Pete Lien & Sons
TRANS COLORADO CONCRETE

CONCEPT LSP PLAN

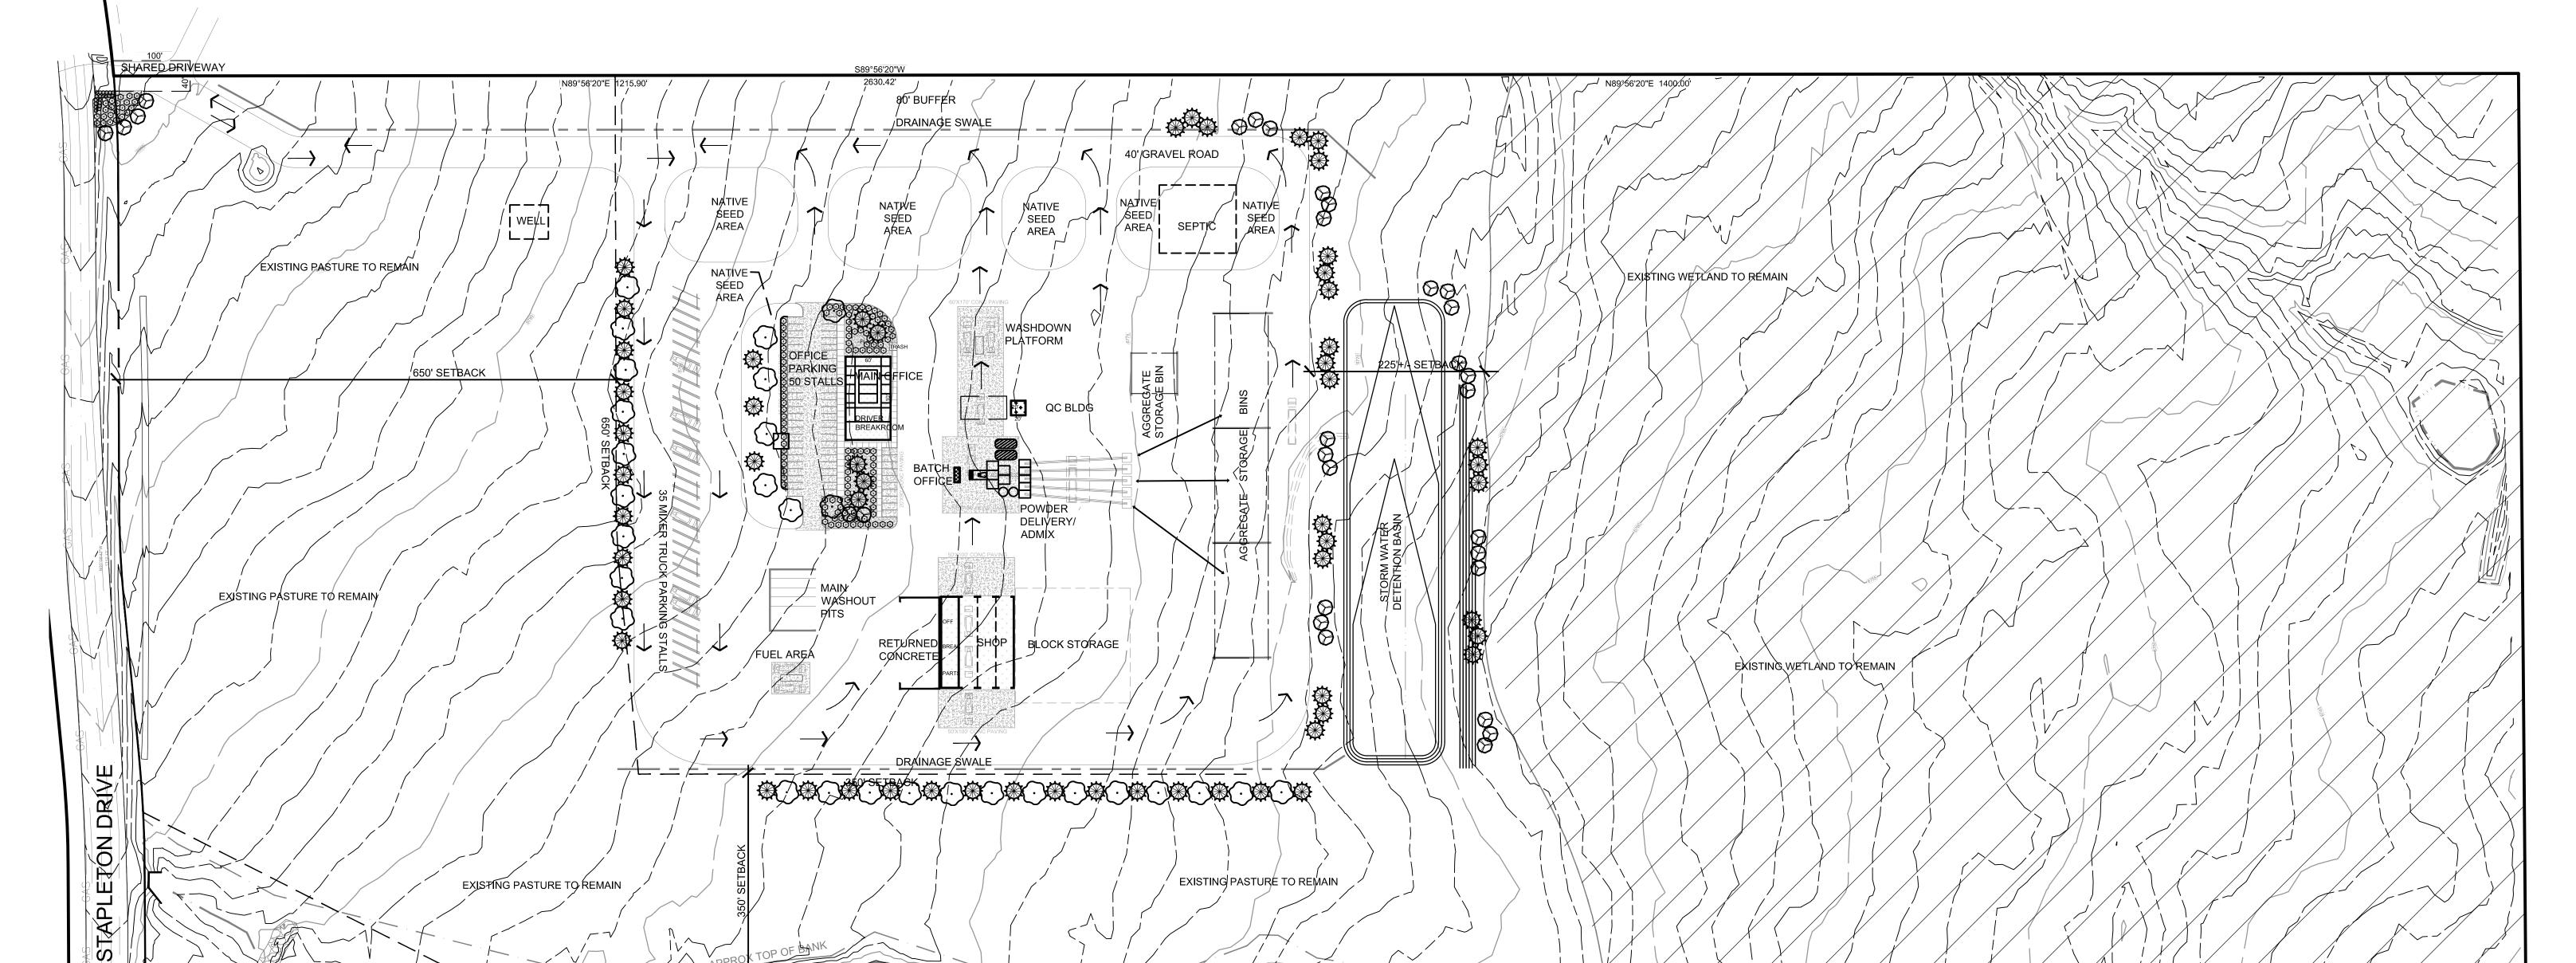
The landscaping plan will be reviewed at the site development plan stage of the application. The requirements of Chapter 6 of the Land Development Code will apply.
